Red Linked Belt Install Tool Modification

DESCRIPTION:

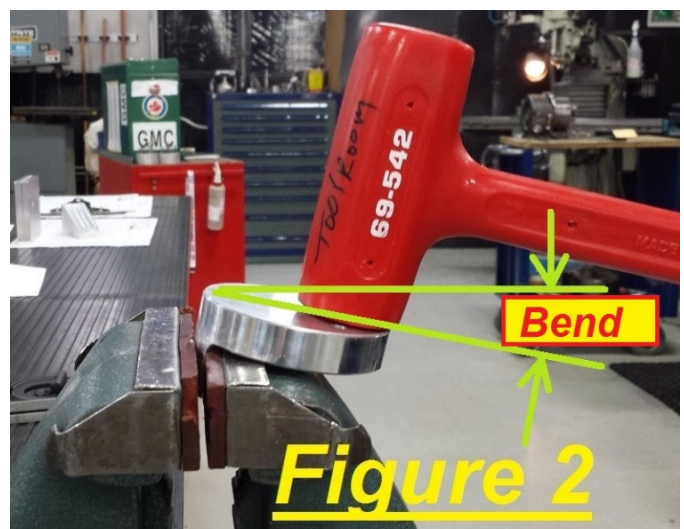
Potential risk for damage / premature failure of linked v-belt for APU generator. During belt installation, there is potential for the linked belt underside tab to be trapped under the tongue of install tool (see picture on right) and may cause the belt tab to overstretch or even crack.

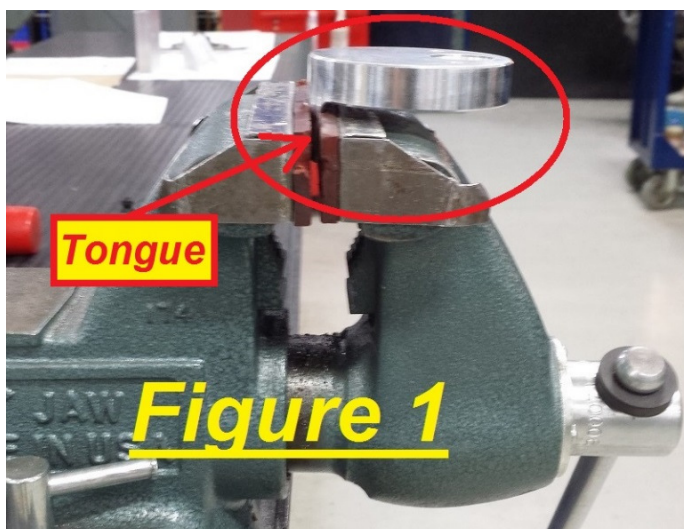
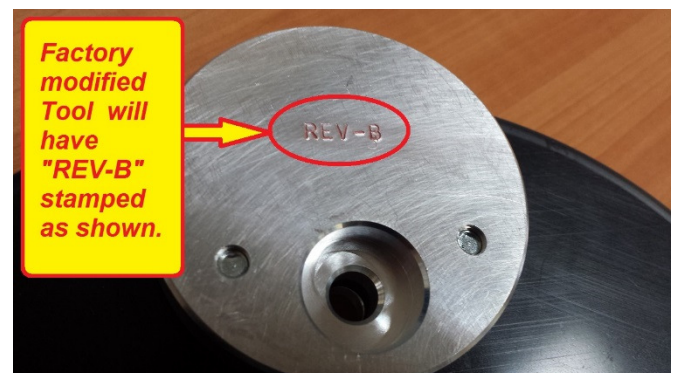
First, determine if your tool has been modified, as shown on the right.

- Disassemble the tool (remove the 2 screws using Hex Key).
- Take the round aluminum part (shown in red circle, *Figure 1*) and clamp the tongue as shown between the padded vise.
- Use plastic mallet and strike top surface until bent approx. 10° to horizontal as shown in *Figure 2*.
